Final Initial Study/Mitigated Negative Declaration

LS Power Grid California Manning 500/230 Kilovolt Substation Project

June 2025

Project Element Map 7 of 23

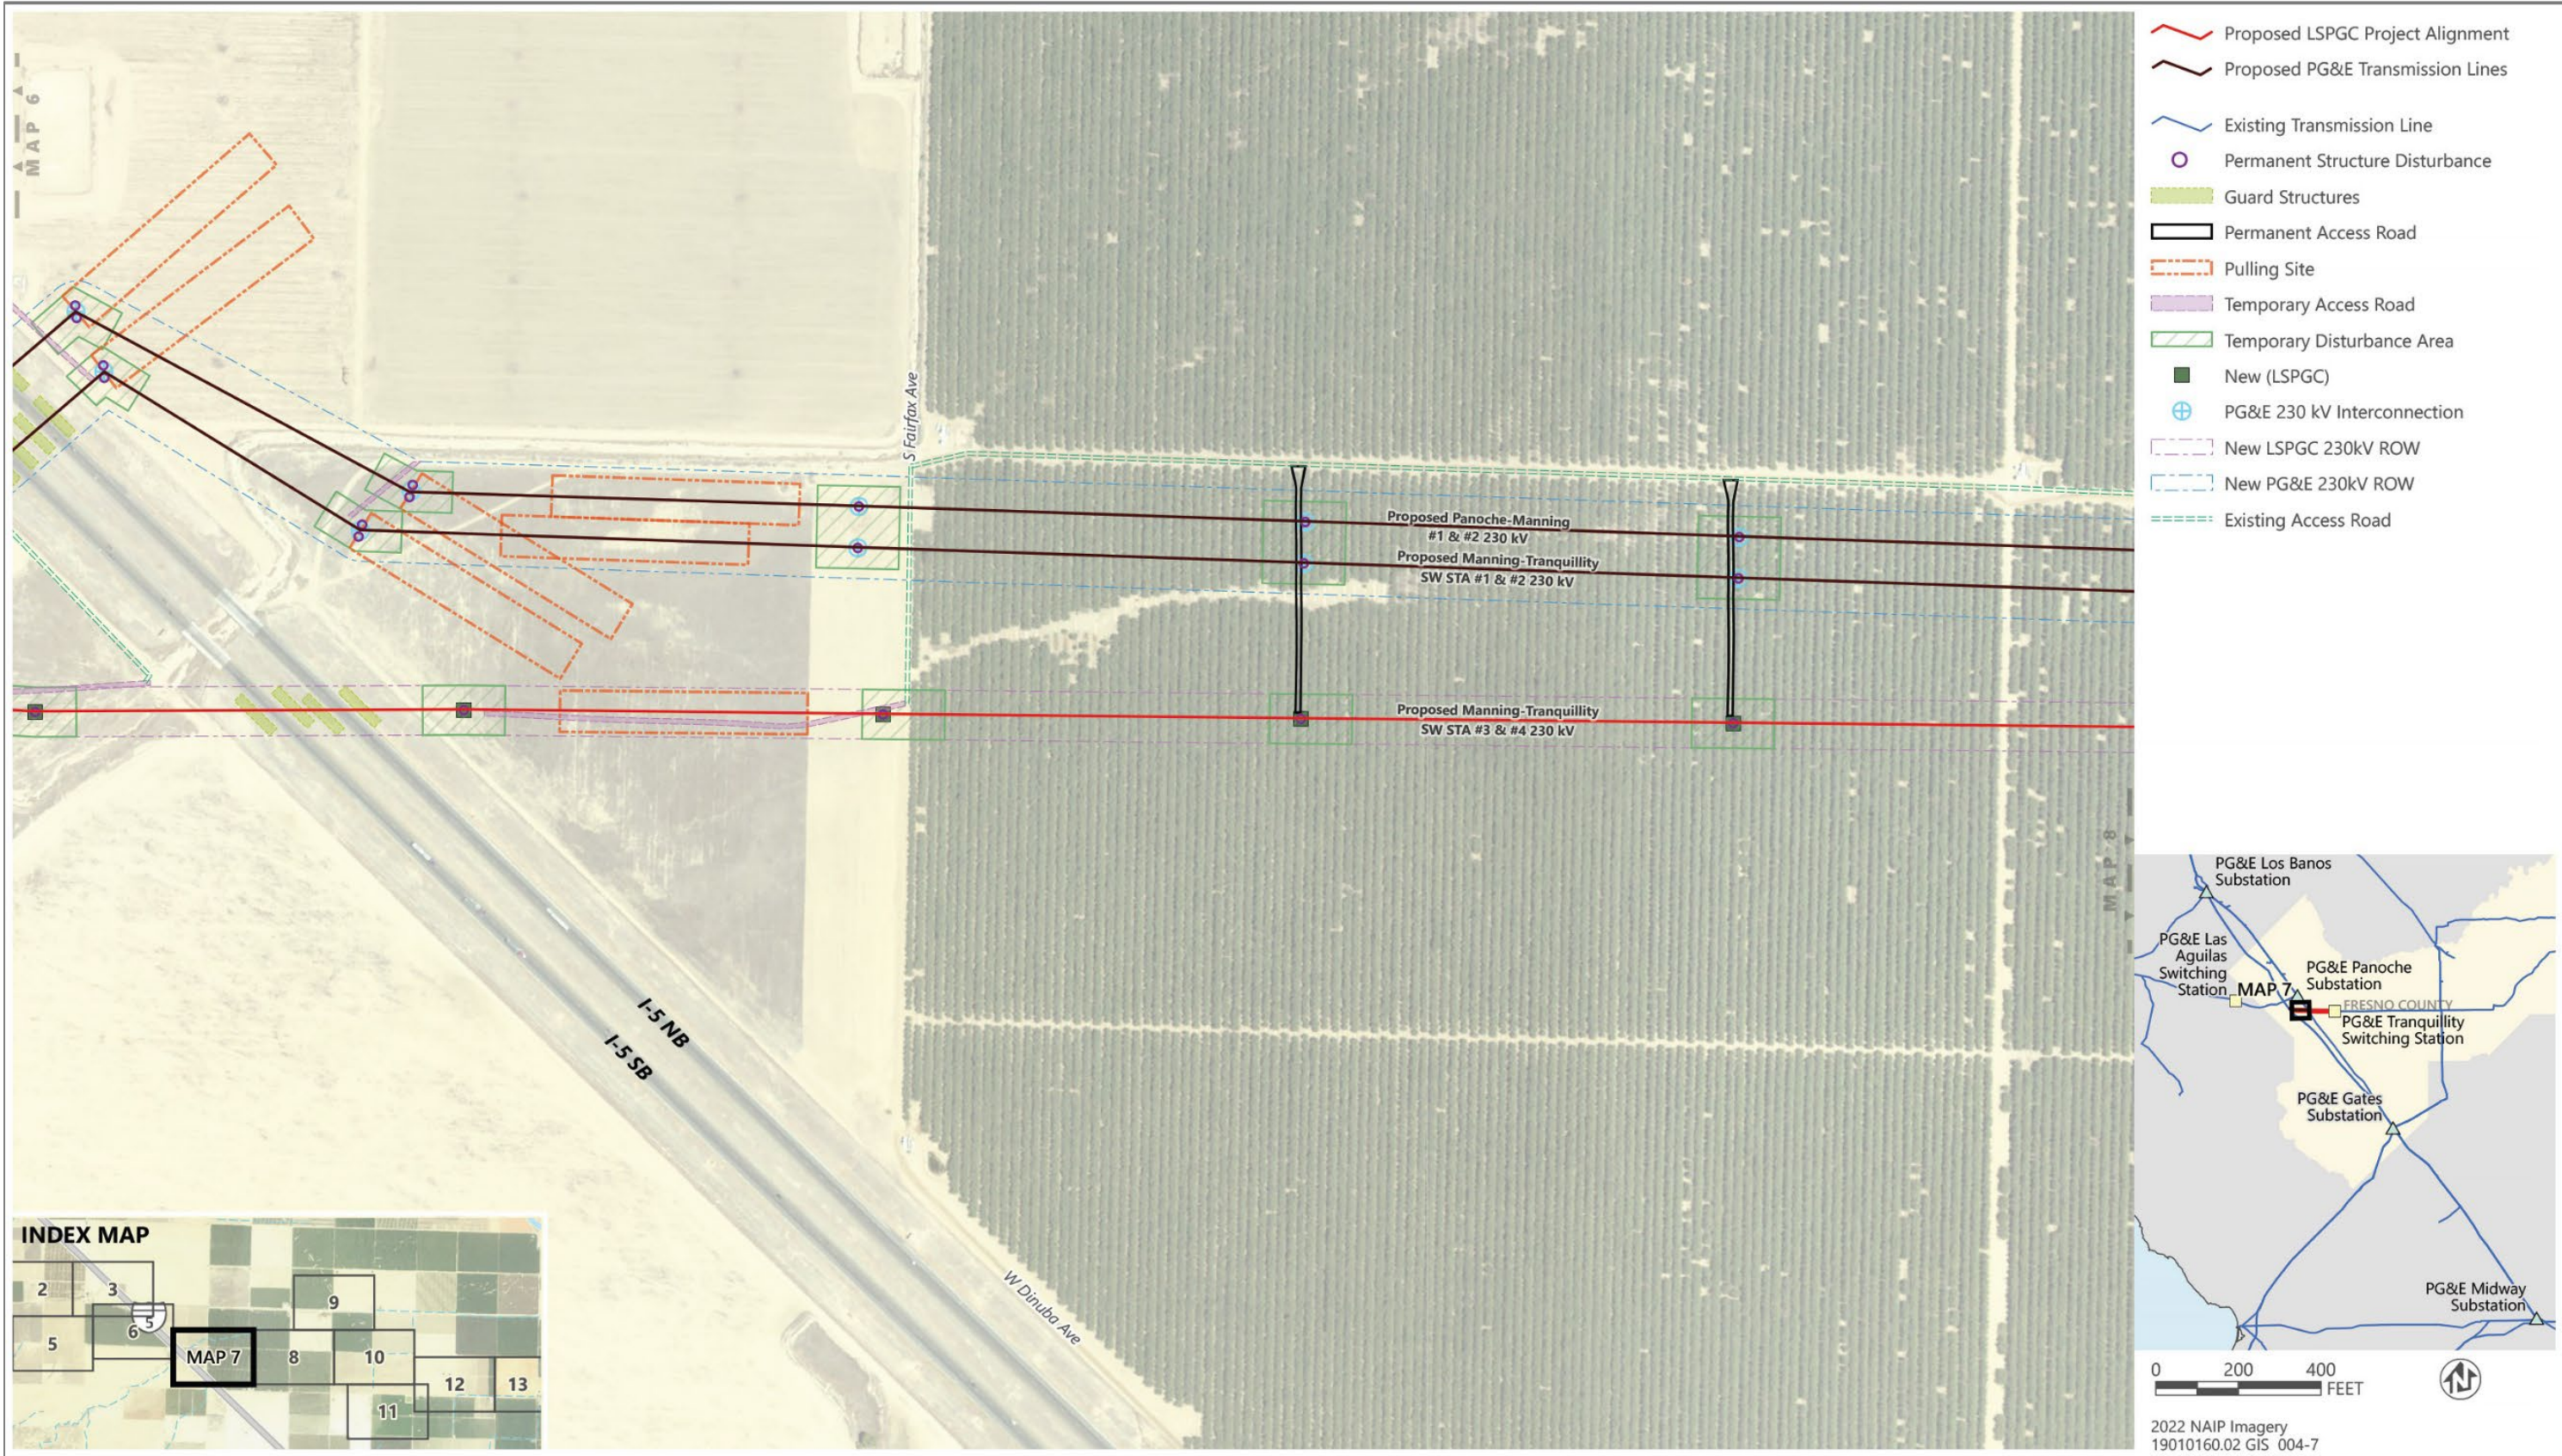
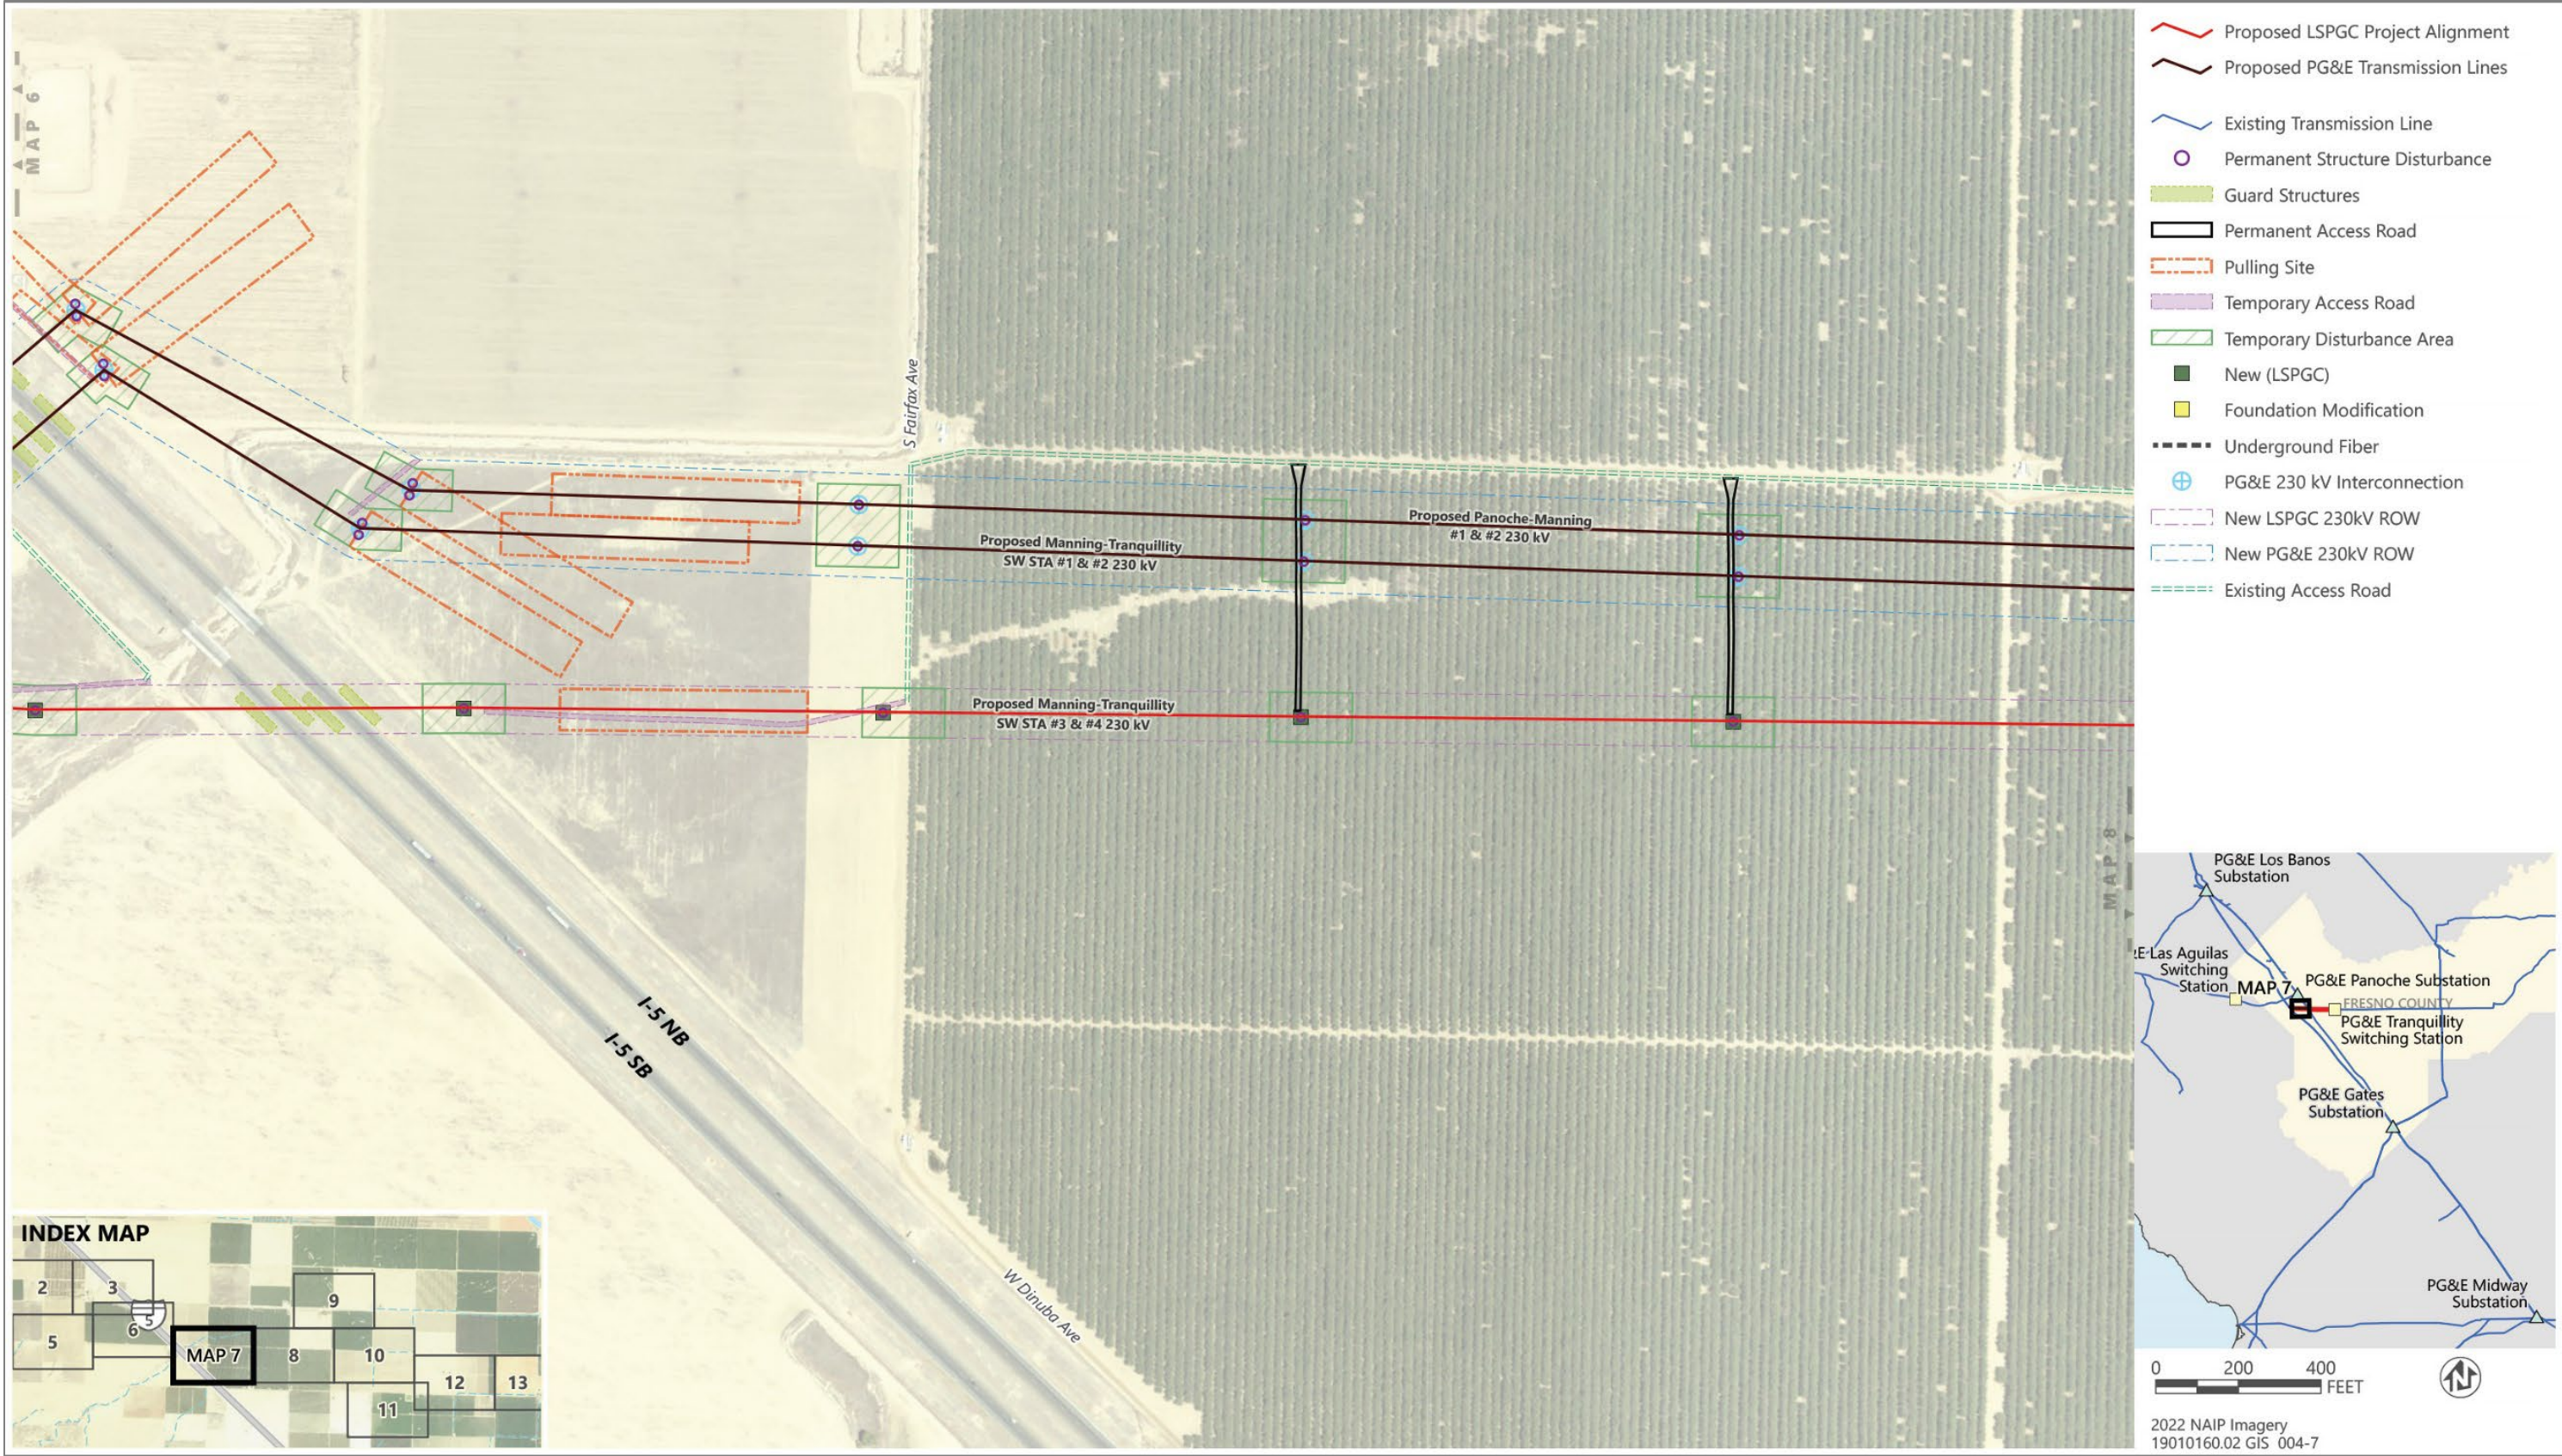
In response to Comment O1-17, revisions have been made to Project Element Map 7 of 23 on page A-7 of the Appendix A to Appendix 1:
